Flood Control Project Maintenance
Levee Inspections

Spring 2020 Levee Inspection Results

Reclamation District No. 0537 Lovdal

Levee Inspection Report By Mile - Spring 2020

Photo 2 of 2 : SP_2020_RD0537_173_6_20200228_00003.jpg

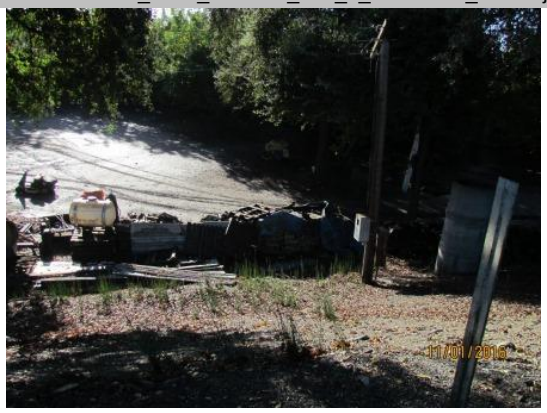
Equipment at the landside toe.

View of equipment at landside toe. Fall 2016.

Photo 3 of 3 : SP_2020_RD0537_173_50_20200228_00032.jpg

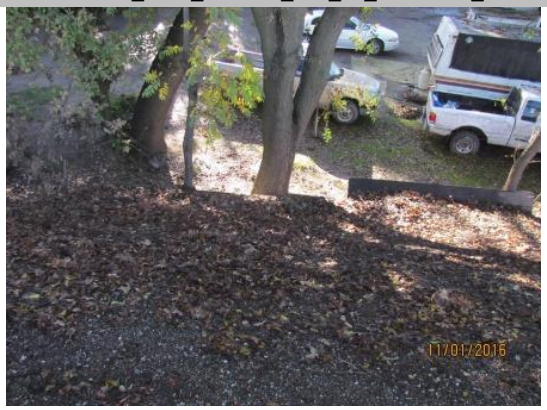
View of the retaining wall at the levee toe on the landward side of the levee looking downstream. The wall is partially broken. Fall 2015.

View of the site. Fall 2016.

Photo 2 of 2 : SP_2020_RD0537_173_37_20200228_00024.jpg

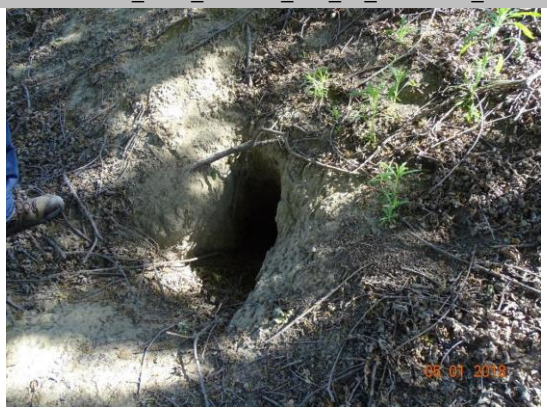
A3 : No rodents visible, but rodent burrows visible; need to backfill and compact or grout burrows.

Multiple rodent holes on landside slope.

Additional rodent hole on the landside slope. Spring 2018.

Photo 3 of 3 : UCIP_SP_2020_46806_17036.jpg

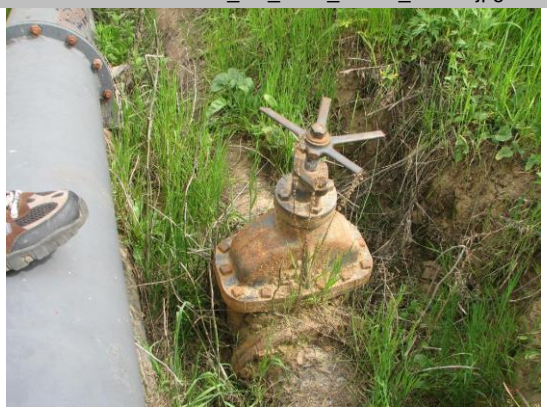
DS_ID:180
FS_ID:46806
EP_NO: 4656
Repair Type: Non-Urgent
Crossing Status: Found
UCIP Comments: Broken gate valve handle on waste pipe.
FIELD_STRUCT_DESC: 12-inch steel irrigation discharge pipe through the levee, 7 feet below the crown. Slant pump column on the riverbank. Timber walkway mounted on a pile structure across the berm to the pump. Siphon breaker in a corrugated metal pipe (CMP) riser on the landside (LS) slope. Concrete pipe riser on the LS. 6-inch waste line down the waterside (WS) bank with a gate valve. (Plans to install a new steel pipe through an existing pipe and to grout the annular space between the pipes through the levee authorized under Permit No. 4656, 1964 - Beatty H. Ramsay, MD). [Additional Reference(s): DWR Levee Log, 2004].
FS Date: 3/18/2013

WS- main pipe and waste pipe with gate valve

Photo 1 of 1 : SP_2020_RD0537_173_19_20200228_00012.jpg

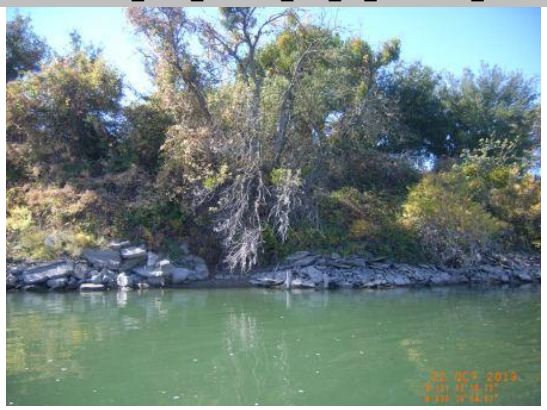
2017 Site ID: SAC 62.9 R
Status: Eroding
2017 Field Notes: Fresh erosion pocket near downstream end.
Site History: 1997 - This may have been a cobble rehabilitation site to the 1957 cobble that was place all the way to the I-80 Bridge. 2000 - Local damage induced by human use. 2003 - Site is still very close to the levee and into the levee toe. 2011 - One new tree has fallen. 2015 - Sites 62.9 and 63 were combined into one site.

USACE 2013 Photo #1
